**SUBDIVISION REVIEW SHEET
ENVIRONMENTAL VARIANCE REQUEST ONLY**

CASE NO.: C8-2019-0080.1B.SH

SUBDIVISION NAME: Persimmons Construction Plans

SUBJECT: **Revised staff recommendation for the Persimmon Construction Plan environmental variance request, C8-2019-0008.1B.SH**

CUT & FILL EXHIBIT

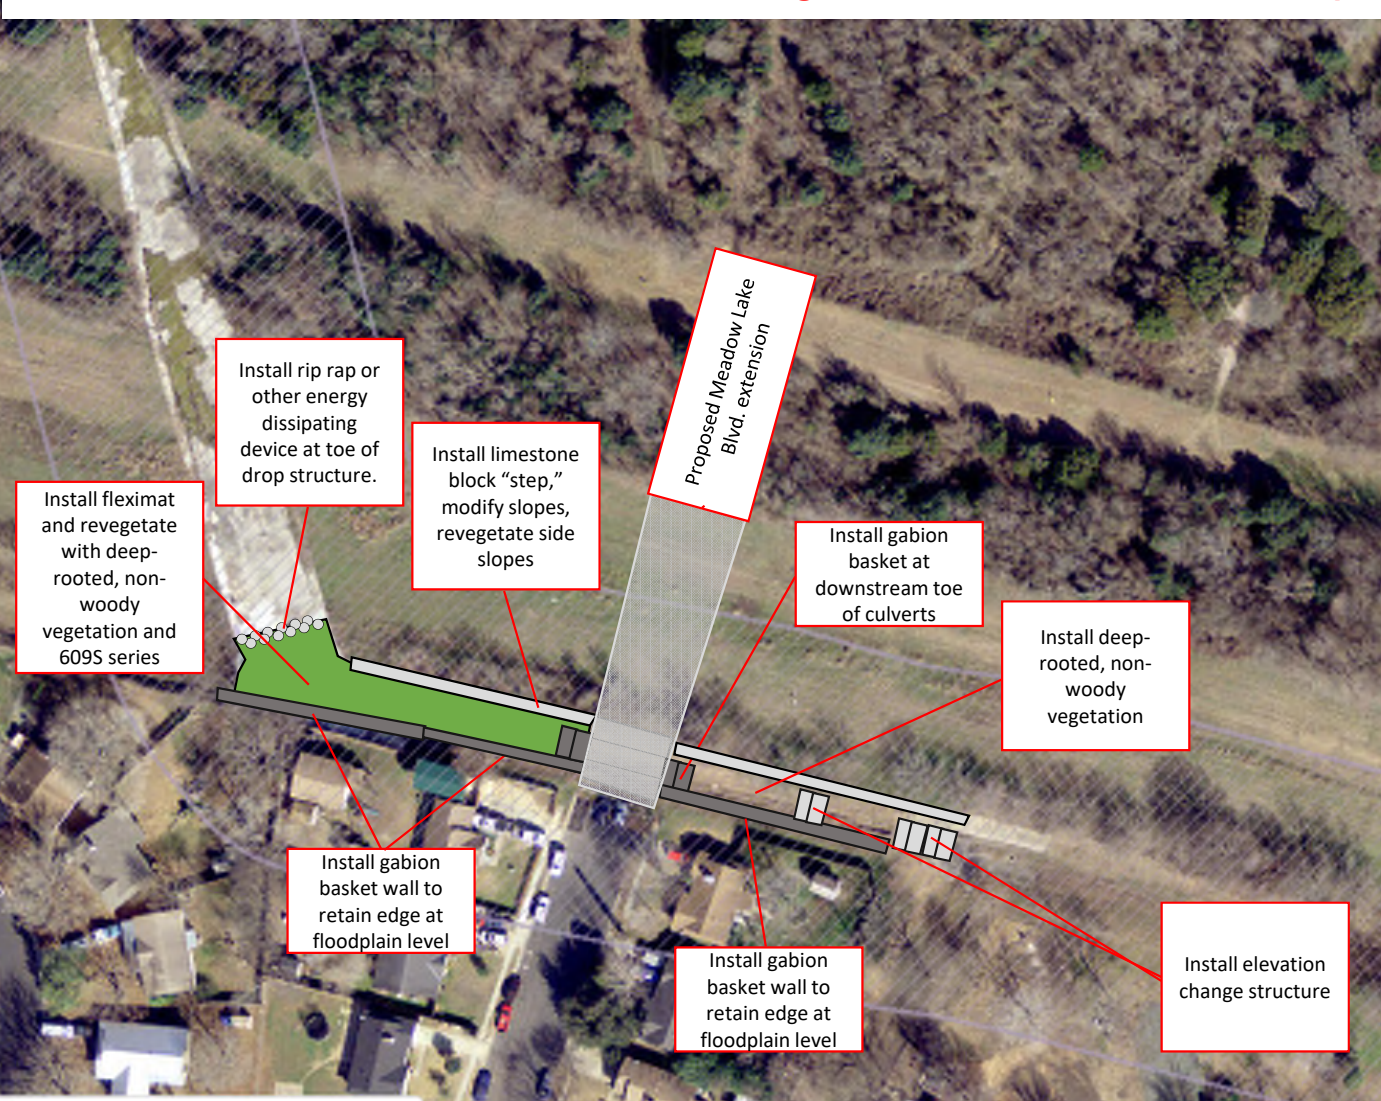
Clearly indicate in what way the proposed project does not comply with current Code (include maps and exhibits)	The 362 sq ft area of cut in excess of 4 ft is necessary for installation of drainage culverts for the Meadow Lake Blvd Road extension project. A cut and fill exhibit is attached.
---	---

- b) Is the minimum deviation from the code requirement necessary to allow a reasonable use of the property;
- Yes** / No The proposed grading results in a small area exceeding the cut limit and in a minimum departure from the code requirement.
- c) Does not create a significant probability of harmful environmental consequences.
- Yes** / No The cut area is located at the channel transition for the culvert and would not result in additional site disturbance. Revegetation would be provided for all disturbed areas.
3. Development with the variance will result in water quality that is at least equal to the water quality achievable without the variance.
- Yes** / No The minimal additional cut will facilitate the culvert without affecting water quality.

Meadow Lake Blvd. Stream Crossing and Restoration Concept

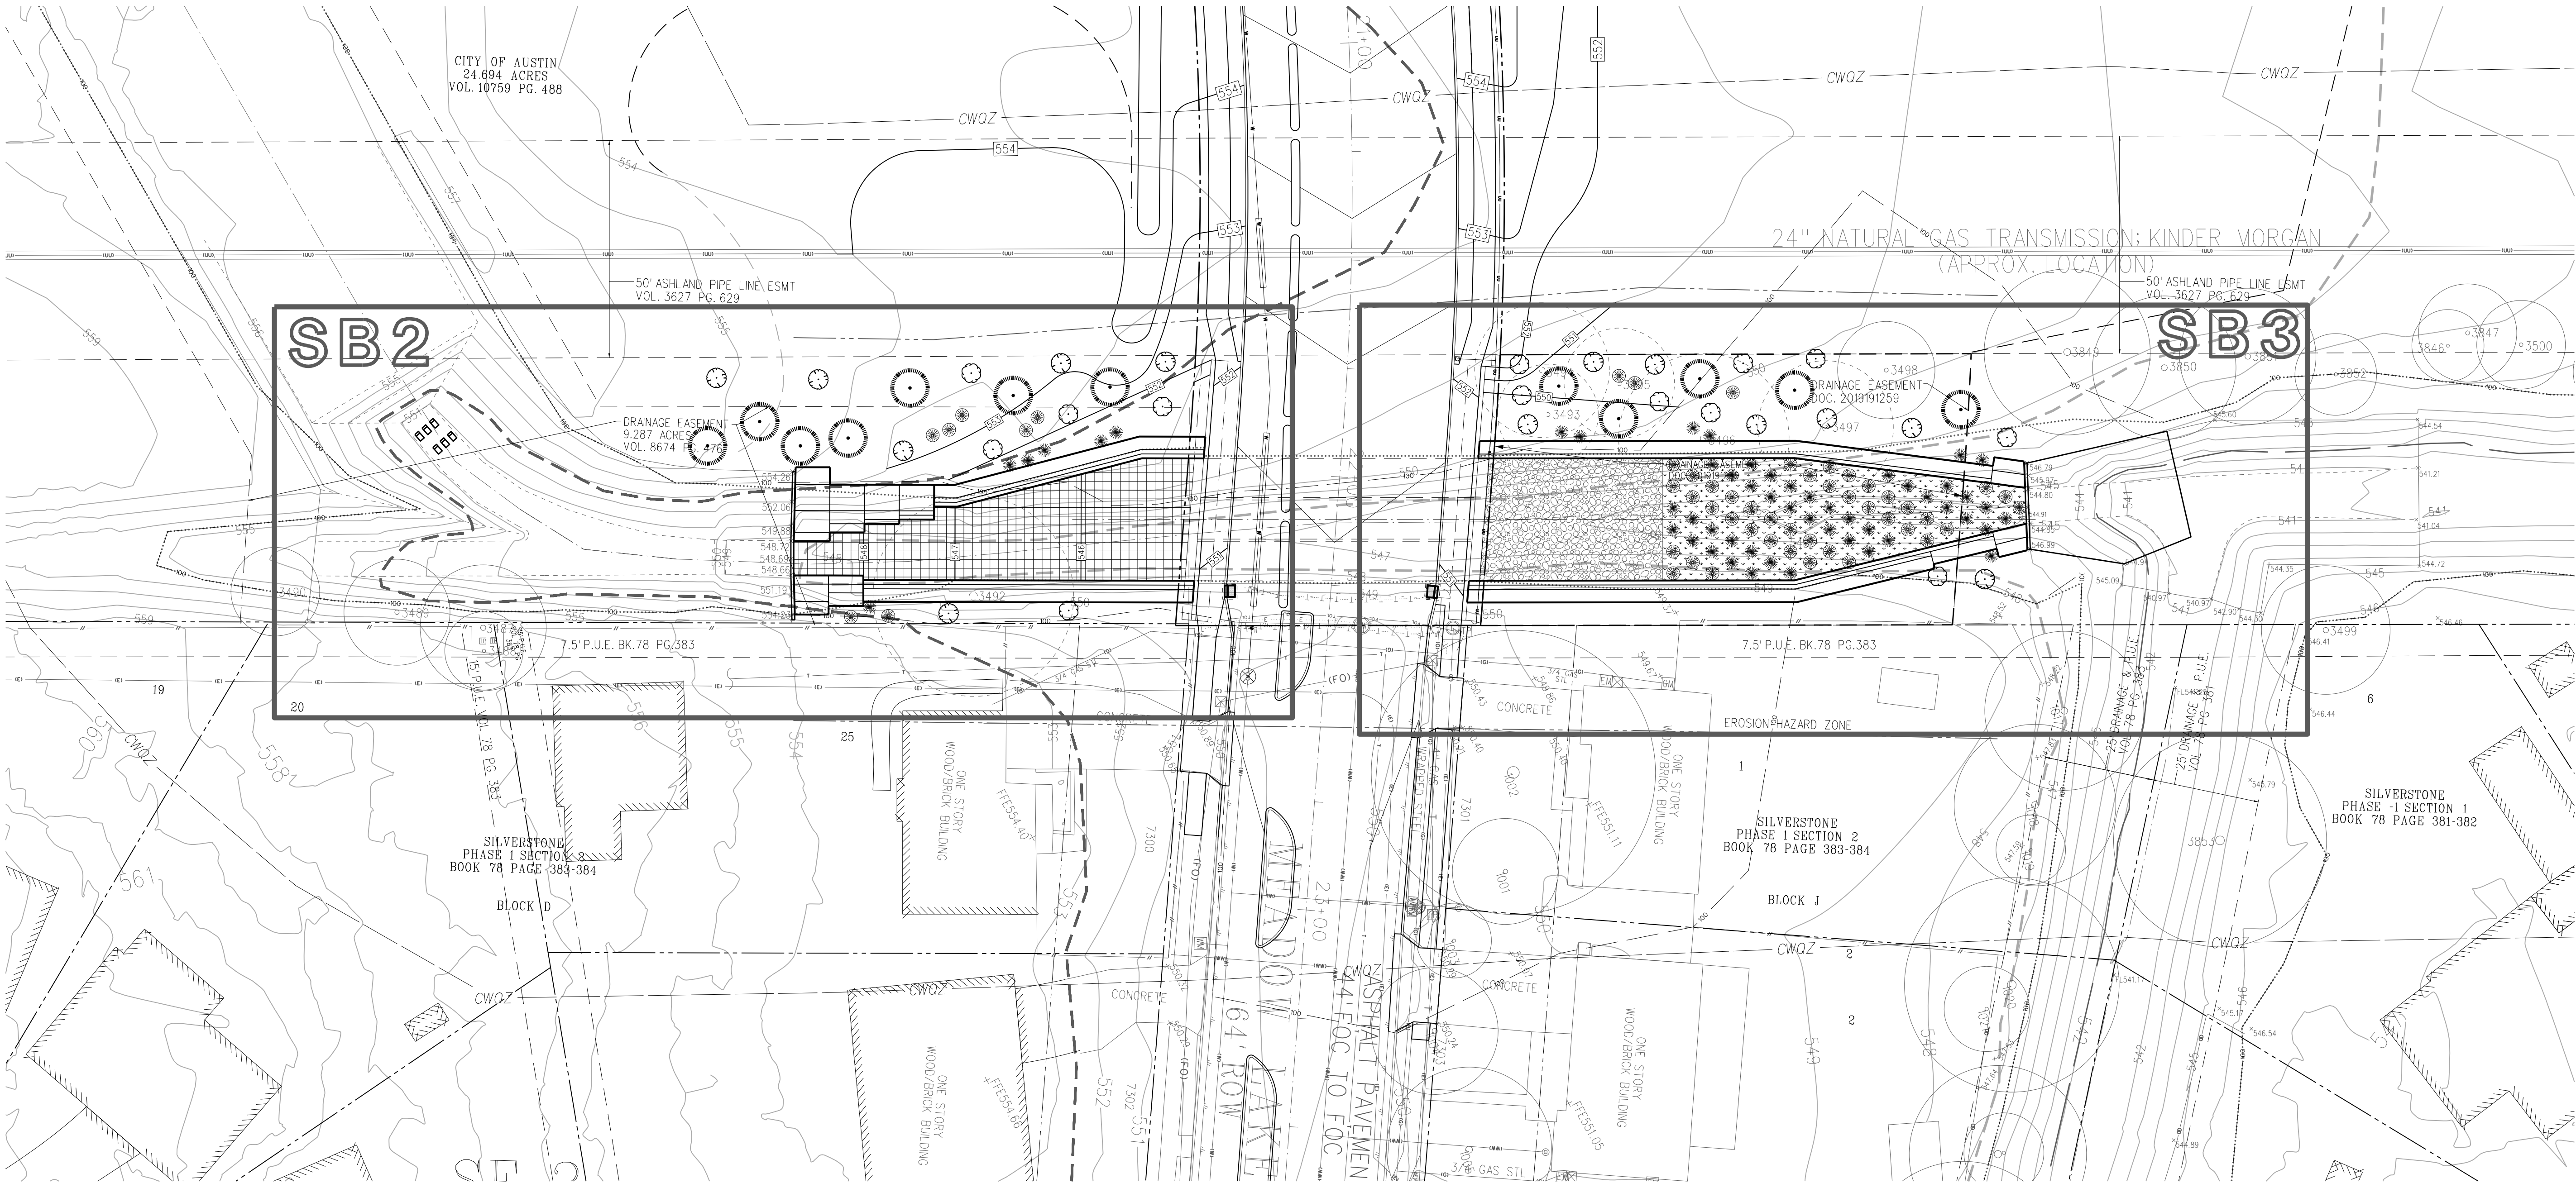
-The proposed roadway extension of Meadow Lake Blvd. threatened to cause further damage and degradation to the classified waterway, furthering endangering the neighboring property owners in an underserved community.

-Install energy dissipation device upstream and downstream to mitigate "rushing water" released from upstream detention pond;

-Stabilize both sides of stream bank to prevent scour and erosion;

-Install new drop structure to repair existing, broken infrastructure;

-Install waterway crossing culverts at a depth that will allow for the 100-year flows to safely pass underneath the roadway without narrowing the channel width, increasing the velocity of flows coming out of the box culverts, and modifying downstream flow patterns; and,

-Revegetate the stream channel with appropriate riparian vegetative stabilization plants and techniques.
